Ryanair submission on Draft Decision on an
Interim Review of the 2019 Determination

(CP3/2022)

Dated, Friday 16th September 2022

Figure 1: Central Functions Opex per pax in 2019 determination and Third Interim 2019 Determination

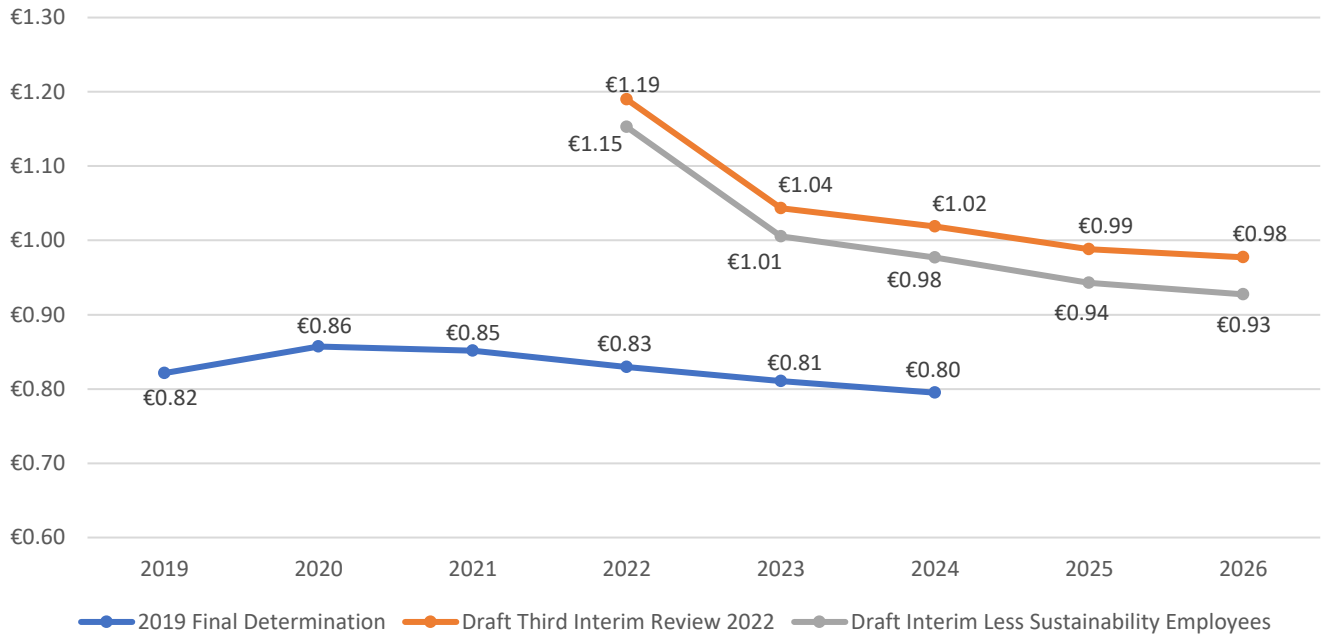
149. The fact (CEPA/TA Report Section 6.1) that expenditure in central functions at Dublin Airport increased by 50% between 2019 is ample demonstration that DAA has not been behaving efficiently. A staffing level of 41 people in these new areas, at a cost of €3.7m, seems extraordinary and cannot possibly be justified. Central functions are the area where an airport should be able to gain maximum economies of scale as it grows. This provides further evidence as to why 2019 actual costs should not be taken as a baseline for any forward-looking estimate of efficient costs.

150. We note also that there is a proposal here to add 10 (rising to 17) FTEs for sustainability related initiatives. The need for these staff has not been justified and would, at least in part, duplicate the proposed compliance staff allowed for in the maintenance function. Any double counting of additional staff in sustainability related functions needs to be stripped out as it, alone, accounts for €0.05 on the price cap by 2026. We are, in any event, unclear why this category of expenditure is treated as new as the environmental obligations deriving from the Paris Treaty in relation to climate change and the need to comply with noise controls arising from the North Runway would have been known at the time of the 2019 Determination. Hence, it is reasonable to assume that such activities were already embedded in existing staffing and there is no requirement for an increment of this scale, which should be pared back.

151. Having regard to the above considerations, we consider that the staffing levels and costs proposed for central functions are excessive and inefficient and should be reduced to be more reflective of what they considered to be efficient in the 2019 Determination. These staff costs represent the second largest cost category after security at c.10.5% of total opex and this deviates substantially from the norm. In particular, the sustainability related element of these costs should be excluded and other efficiencies realised. Furthermore, CEPA/TA suggest only a very marginal reduction in the share of opex made up by central functions as the airport grows. This strongly suggests that the additions in this area are not efficient, and not reflective of the high level of fixed costs in this functional area that would not be expected to increase as an airport grows.
